# Modification of Minister's Approval

61 Mobbs Lane, Epping (former Channel 7 site)

MP 05\_0086 MOD 2 including:

**Figure 10:** Proposed building separation diagram as contained in PPR, which illustrates area of non-compliance between Building 11 and 12 (red circle)

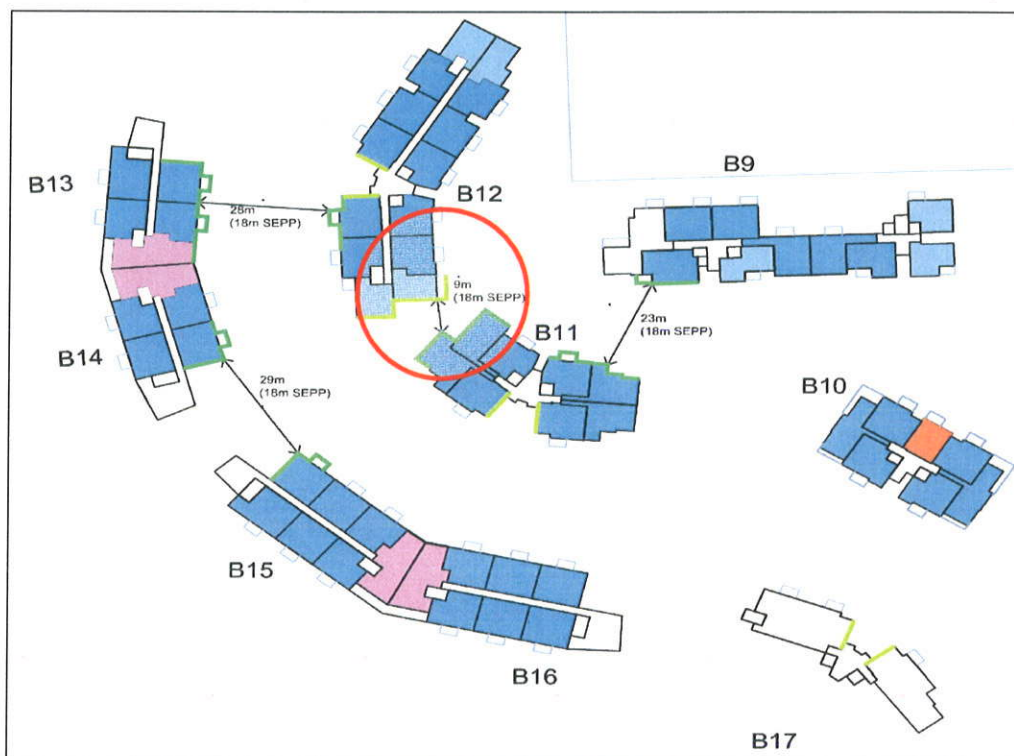
The only area of non-compliance occurs between Building 11 and 12 where a minimum separation of 8 metres is provided between the habitable rooms of Building 11 and the habitable rooms containing privacy screens of Building 12, which is between 4 to 9 metres less than the Code requirement (depending on which level is being considered). **Figure 10** below illustrates the area of non-compliance.

The variation to the building separation requirement is considered to be minor and acceptable in this instance. Adequate residential amenity will be maintained through the inclusion of privacy screens and the outlook of the apartments will be predominantly towards internal streets and open space areas, reducing the opportunity for overlooking neighbouring dwellings. Furthermore, the building envelopes are offset to reduce direct overlooking.

Further detailed consideration of residential amenity will occur during the assessment of future applications, which has been reinforced through comments in the PPR. Residential amenity may be further improved through the introduction of additional privacy screens and/or adjustments to the layout of balconies and windows and the orientation / internal layout of apartments.
